Access Compliance Report Public Rights-of-Way (Curb Ramps)

Main Street: AIROSO_ST Cross Street: CIMA_DR Location: W

ADA ID: RPRK211119145736 Ramp Type: Type 1 - Perpendicular Diagonal Initial Pass/Fail: Fail Overall Compliance: No Severity Score: 2

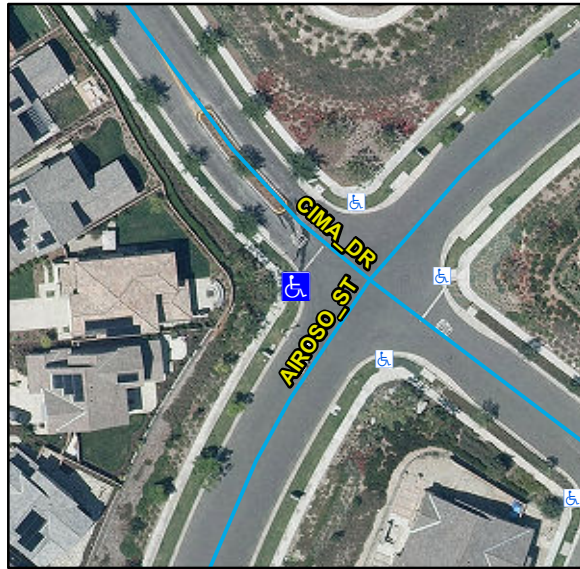
Compliance	Description	Data	Compliance	Description	Data
N/A	Ramp Length (in)	54	N/A	Flare Type LT	
Yes	Ramp Width (in)	61			N/A
Yes	Ramp Run Slope (%)	8.1	N/A	Flare Slope LT (%)	N/A
No	Ramp Cross Slope (%)	3.8	N/A	Flare Traversable LT	N/A
N/A	Landing Present	N/A	N/A	Flare Type RT	
N/A	Landing Length (in)	N/A			N/A
N/A	Landing Width (in)	N/A	N/A	Flare Slope RT (%)	N/A
N/A	Landing Run Slope (%)	N/A	N/A	Flare Traversable RT	N/A
N/A	Landing Cross Slope (%)	N/A	N/A	DWS Provided	N/A
N/A	Landing Movement Obstructed?	N/A	N/A	DWS Contrast	N/A
	Landing Movement Type	N/A	N/A	DWS Length (in)	N/A
N/A	Landing Shared	N/A	N/A	DWS Full Width	N/A
N/A	Clear Space	Yes	N/A	DWS Offset Left (in)	N/A
N/A	Clear Space To Crosswalk (in)	N/A	N/A	DWS Offset Right (in)	N/A
N/A	Marked Crosswalk 1	No	N/A	Marked Crosswalk 2	No
	Crossing 1 Direction	SE		Crossing 2 Direction	NE
	Marked Crosswalk 1 Width (in)	N/A		Marked Crosswalk 2 Width (in)	N/A

N/A	Ramp Inside Crosswalk 1	N/A	Yes	Ramp Inside Crosswalk 2	N/A
	Crossing 1 Slope (%)	3.7		Crossing 2 Slope (%)	0.5
	Crossing 1 Cross Slope (%)	1.6		Crossing 2 Cross Slope (%)	3.3
N/A	Gutter Ponding	N/A	No	Curb Slope	12
Yes	Gutter Lip Height (in)	0		Road Run Slope (%)	4.7
N/A	Gutter Run Slope (%)	N/A		Road Cross Slope (%)	5.3
N/A	Gutter Cross Slope (%)	N/A			
Yes	Overall Surface Condition: Acceptable		Yes	Perp Joint Present	Yes
	Cross Gutter Present?	No		Spandrel Present?	No
	Replace Cross Gutter?	N/A		Replace Spandrel?	N/A

Remove & Replace Curb Ramp With Two New Directional Ramps or Equivalent.

R304.2.2, R304.5.3, STD 1115
